PCN# 20250110001.1

**Qualify New Assembly material, Bond wire removal and
datasheet update for select F65 devices
Change Notification / Sample Request**

Date: January 17, 2025

Wire bonding diagram:

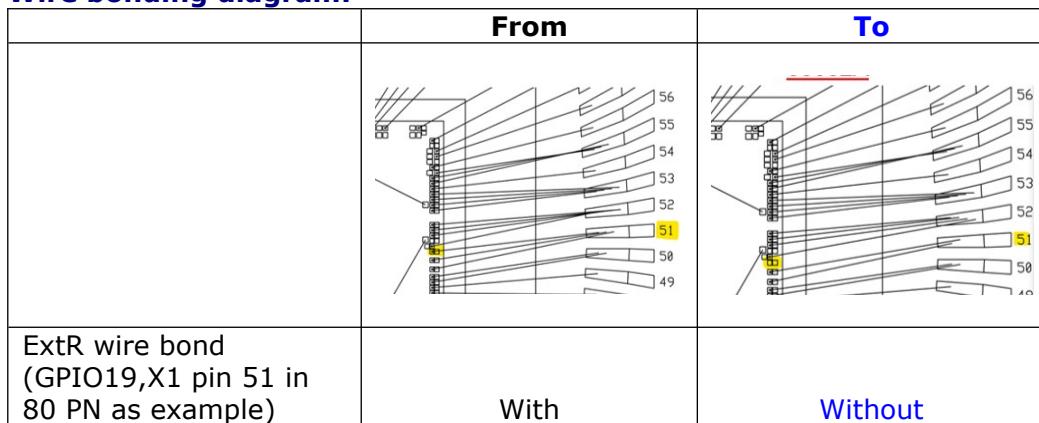
Texas Instruments is pleased to announce the qualification of new assembly material, removal of ExtR wire bond (ie. GPIO,X1- pin 51 in 80PN package) and data sheet update for devices listed in "Product affected" section below. Devices will remain in current assembly facility and piece part changes as follows:

Material	Current	Proposed
Mold compound	4212581	4211649
